**Re: InnPower Corporation (InnPower)
Application for 2024 Distribution Rates
Ontario Energy Board File Number: EB-2023-0033**

OEB Staff Interrogatories
2024 Electricity Distribution Rates Application
InnPower Corporation (InnPower)
EB-2023-0033
July 18, 2023

Figure 5.4-3: Forecast Net Expenditures by Investment Category [Excl. BATU & TS Project]

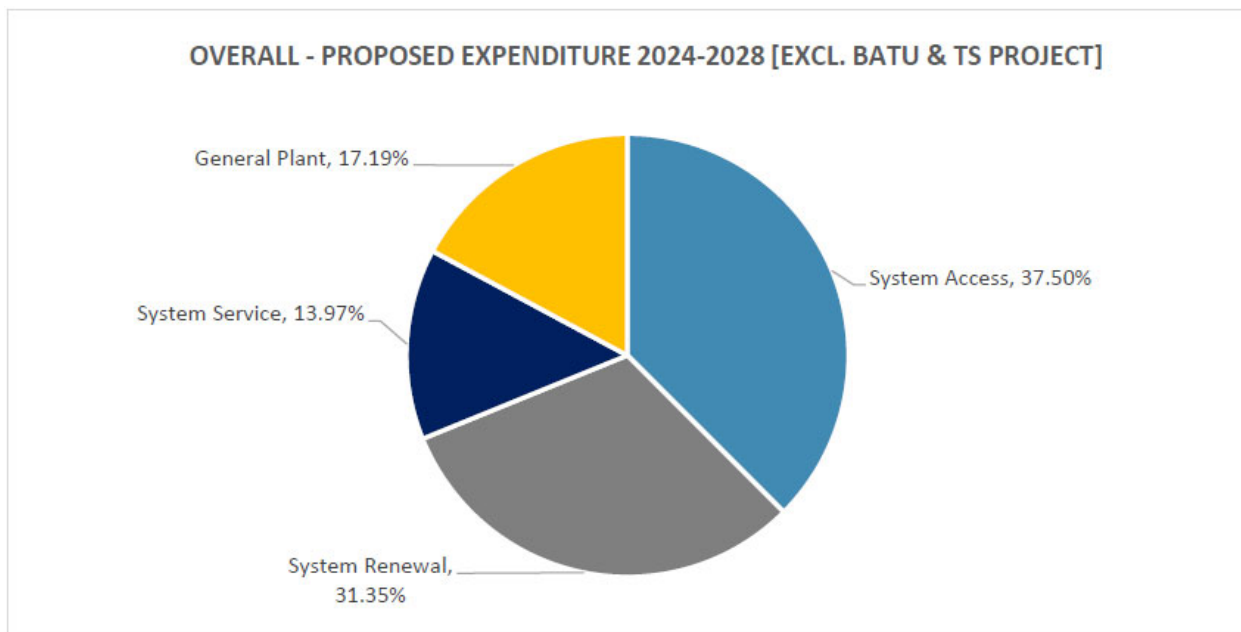
Excluding the Barrie Area Transmission Upgrade (BATU) and TS Project costs, System Access expenditures represent the largest planned capital expenditure over the forecast period, at 37.5% of overall spending. This represents an increase from 26% of overall spending from the historical period.

- a) Approximately 48% of these expenditures represent servicing new subdivisions.
- Please provide additional information on the specific projects (i.e., which subdivisions are expected to be developed and when) that informed InnPower's planned System Access expenditures over the forecast period.
 - For each of the projects identified, has an Offer to Connect agreement been executed?

Figure 5.4-15: System Renewal Comparative Expenditures

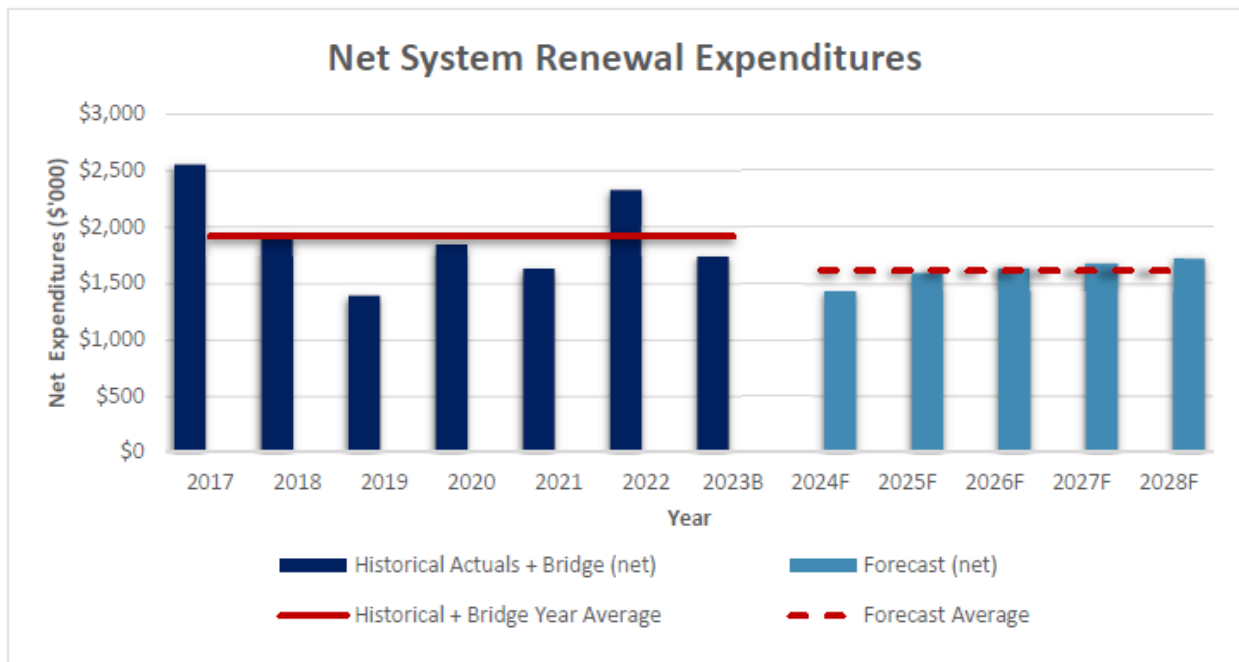
InnPower's planned average System Renewal spending during the forecast period is expected to be 16% less than what was spent on average during the historical period and bridge year, as shown in the figure below. How will InnPower ensure that this reduced spending will not have adverse impacts on the health of system assets in the coming years?
